AIR RESOURCES BOARD

Exeuctive Order G-70-17-D

Relating to the Modification of the Certification of the
Emco Wheaton Balance
Phase II Vapor Recovery System

IT IS ORDERED AND RESOLVED: That the certification Executive Order G-70-17-C issued on May 22, 1979 for the Emco Wheaton balance Phase II vapor collection and disposal system is hereby modified to:

Exhibit 5

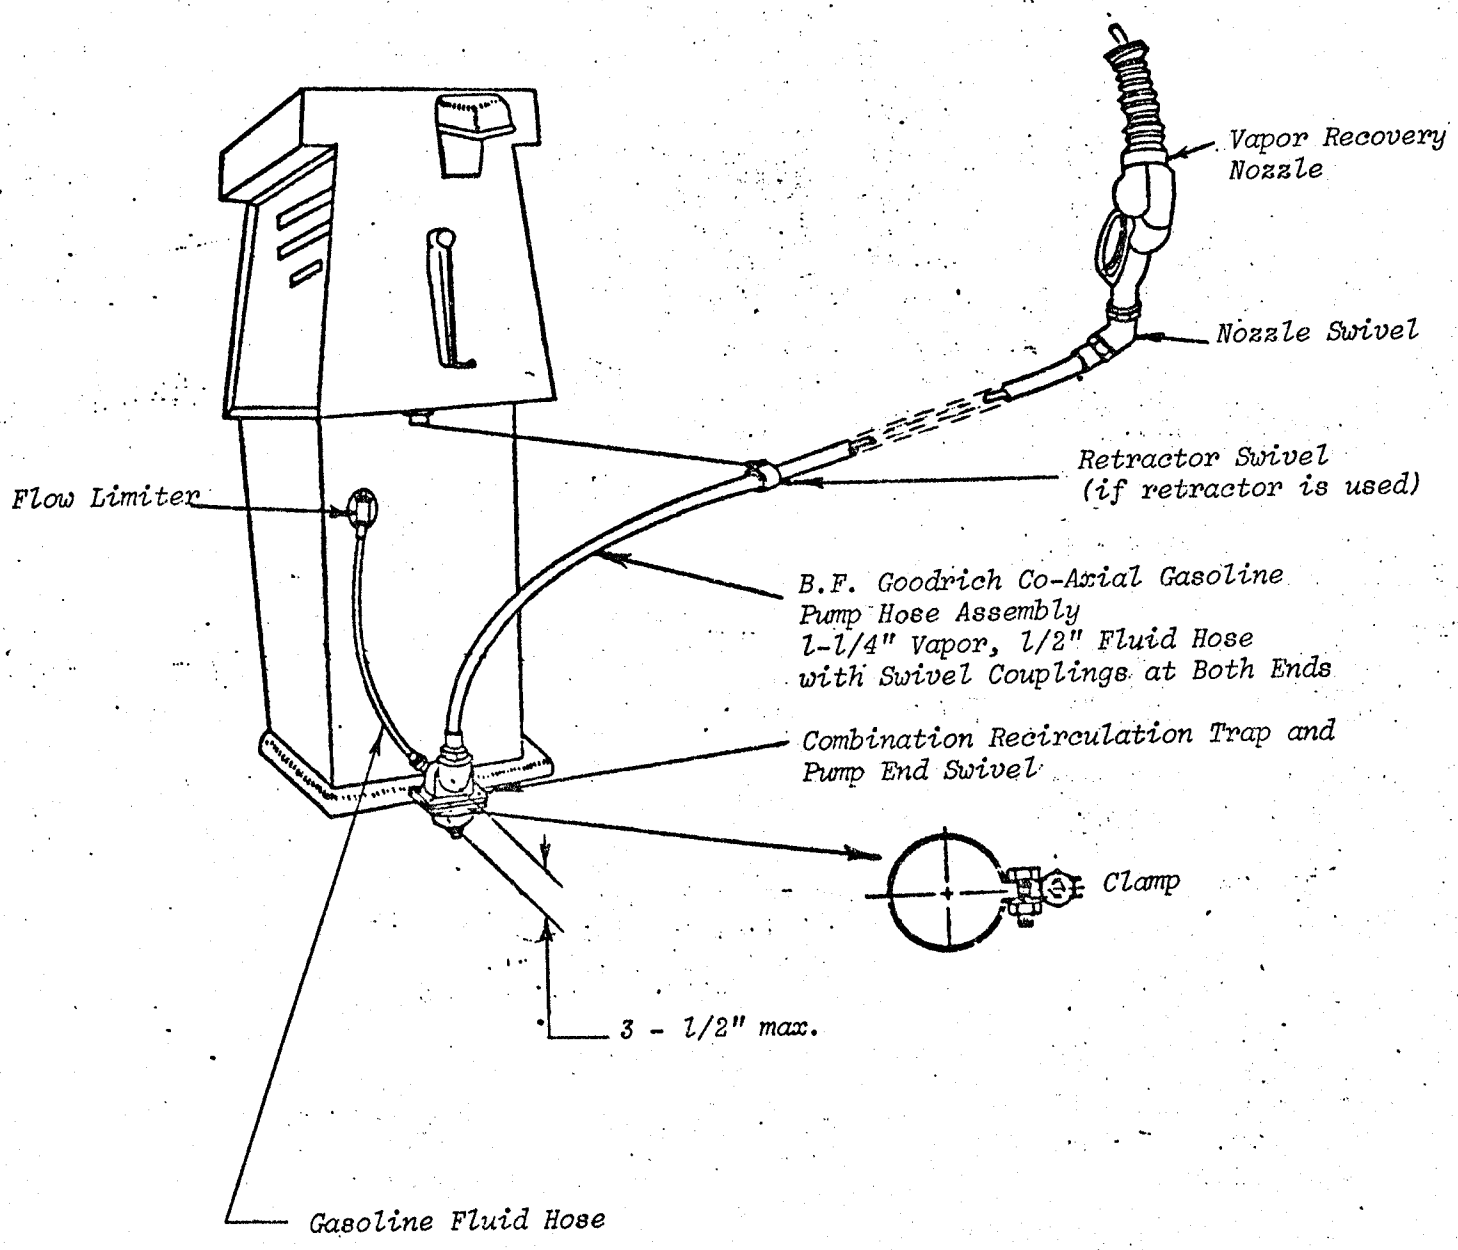
1. Include the B.F. Goodrich co-axial hose assembly, described in Exhibits 5, 6, 7, and 8 as an alternate hose configuration,

Executive Order G-70-17-D
Emco Wheaton Phase II Balance Vapor Recovery System
Alternate Hose Configuration-B.F. Goodrich Co-Axial Hose Assembly
with
Combination Recirculation Trap
And Pump End Swivel
(see Exhibit 8 for Component List)
(See Exhibit 3 for Pressure Drop Requirements)
